Memorandum

To: Sean Dundon, Chair and Members of the Portland Planning Board
From: Shukria Wiar, Planner
Date: June 22, 2018
Re: Five-Unit Condominium, 24 St. Lawrence Street, Kelly and Walter Williams
Project #: 2017-242 CBL: 016 J006001
Meeting Date: June 26, 2018

Figure 3: Proposed Site Plan

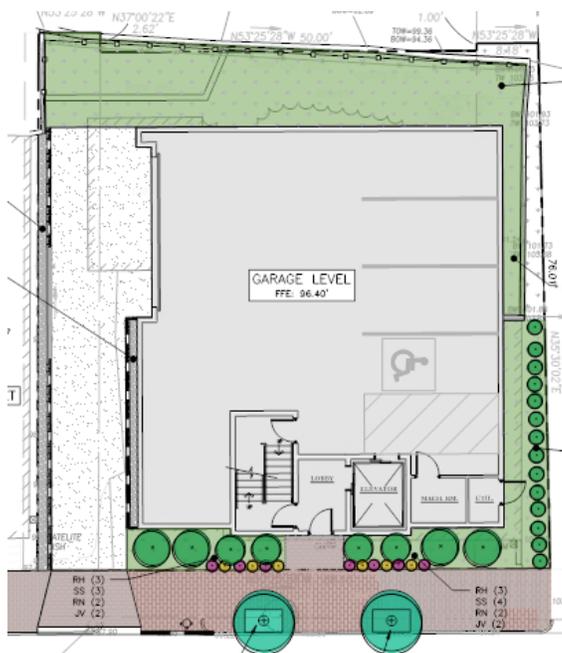
- **Site Design:** The Planning Board and staff sought to have the driveway on the side of the lot instead at the middle, to continue the historical rhythm of house driveway house. **The project was revised with the garage access on the downhill side of the site.** This structure was reduced in width to accommodate the drives, thus reducing the scale impact of the three-story building.

Staff Comments: The applicant is now proposing the driveway to be at the southern side; therefore, the garage is no longer at center of the building façade. The garage door is now tucked away at the side of the building. Vehicles will enter the site through a 10-foot driveway, which is sloped down into a lower level garage on the side. The number of the parking spaces has not changed and is still five spaces. Staff has reviewed the revised plans and finds them acceptable.

All five of the units will share access via a common entrance on St. Lawrence Street. Vehicular circulation is no longer centrally located on the site but rather accessed from the side driveway from St. Lawrence Street. Parking for each unit will be located underneath the new building. The R-6 zone does not require parking spaces for the first three units. However, the applicant is now proposing five parking spaces (has reduced it by one parking space). Two bicycle parking spaces are also proposed as part of this project. A designated area for snow storage is located adjacent to the proposed building. Landscaping is shown at the front and rear of the property.

Figure 4: Rendering of Front of Proposed Building

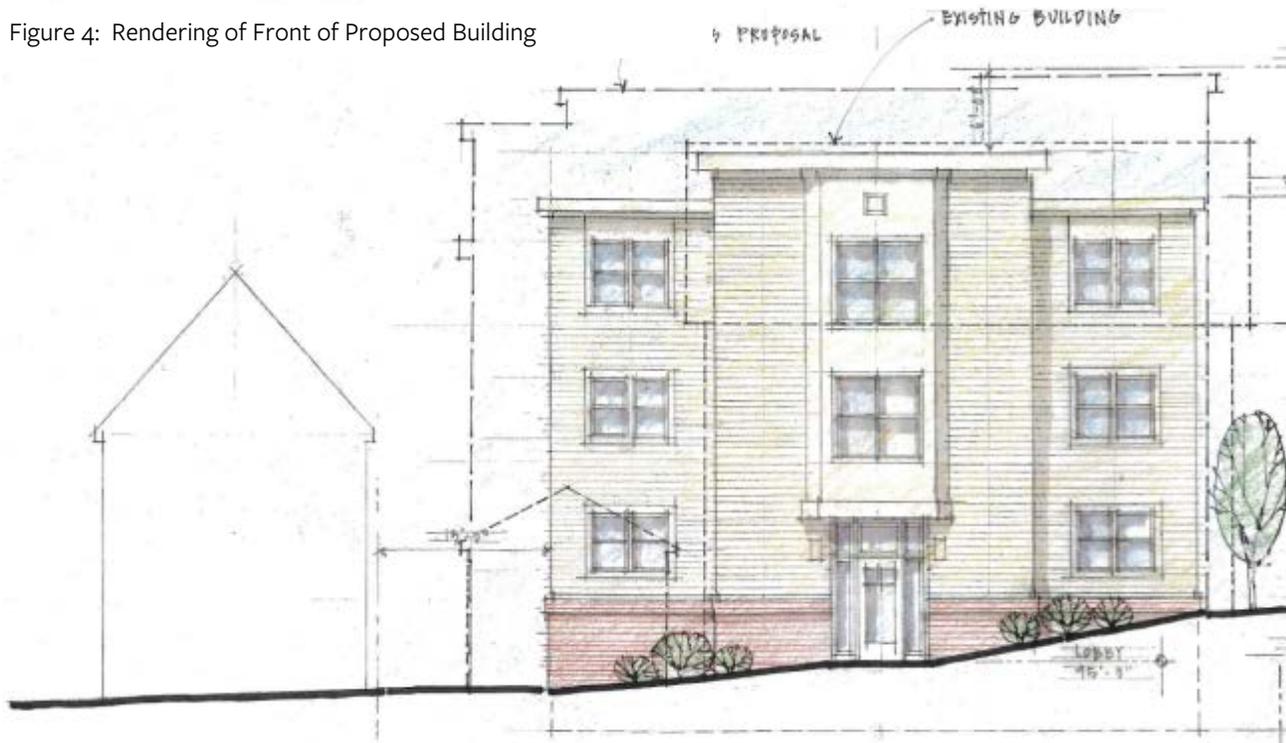
- The revised design was brought down in height from four stories (above the grade plane) to three stories. This was accomplished by locating the garage level down into the site. The overall height has been reduced from approximately 45' to 38' (which is close to the ridgeline of the existing house, see Elevations).

- The original design had the access to the garage level (via the overhead door) directly on the front (St. Lawrence street) facade. The revised access is on the downhill side of the site and the overhead door has been relocated.

- The square windows in the stair towers have been removed. Windows with a more vertical, traditional proportion are used.

Staff Comments: The proposed building has been reduced in scale and mass. The garage entrance has been removed and now is located on the side of the building. Caitlin Cameron, Urban Designer, reviewed the changes and finds them acceptable, [Attachment 3](#).
